## **Waterloo Metro Over Station Development**

### **Southern Precinct - S4.55 Modification – Traffic Statement**

Figure 2 – Modified Ground Floor Layout

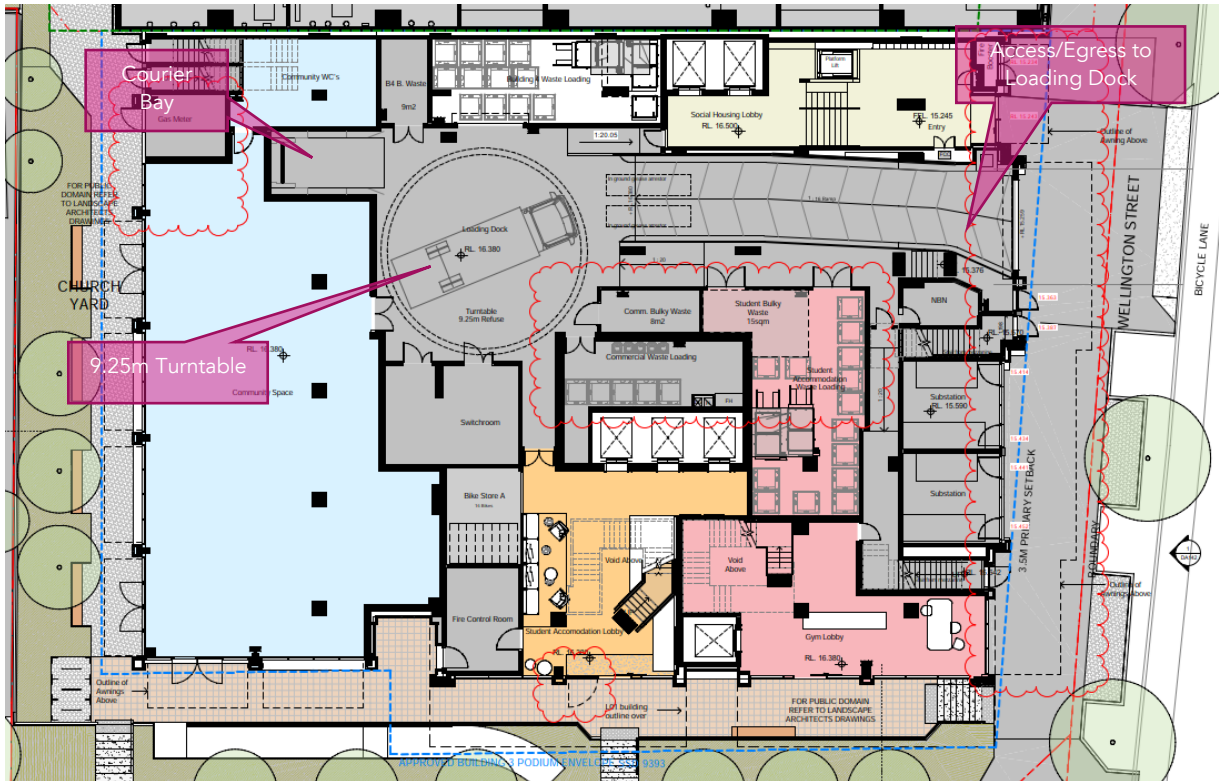
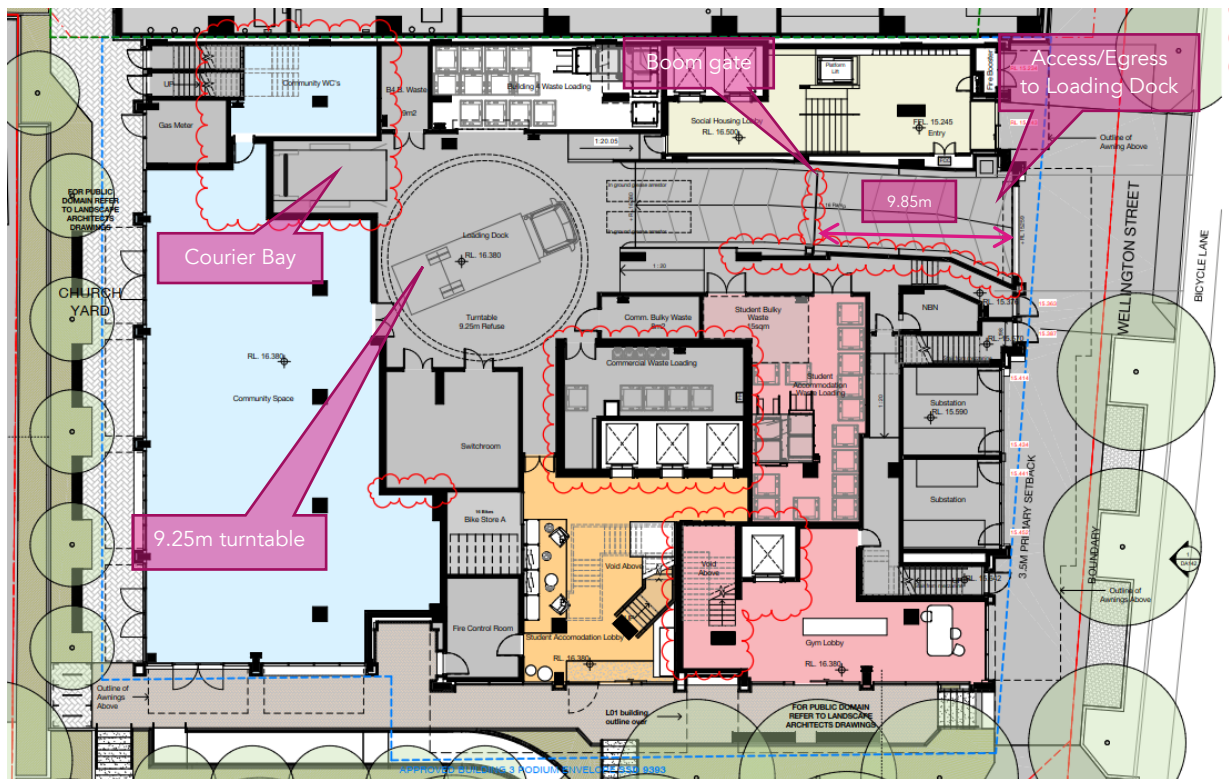
The modification seeks to reconfigure the loading dock layout, with the alterations being:

- Minor realignment to the access kerbline and walls; and,
- The provision of a security boom gate,

This modification provides a security provision of a boom gate to control access to the loading dock during operating hours. The boom gate is set back from the property boundary by 9.85m, which is adequate to accommodate the largest expected vehicle, being the 9.25m City of Sydney waste collection vehicle

Other arrangements such as the access width, grade and headroom have not been modified and / or reduced.

The revised layout meets the requirements of AS2890.1 and AS2890.2 or has been assessed on a performance basis and has been deemed to be fit for purpose.

Therefore, from a parking and traffic perspective, **ptc.** endorse the proposed change to the ground floor configuration.
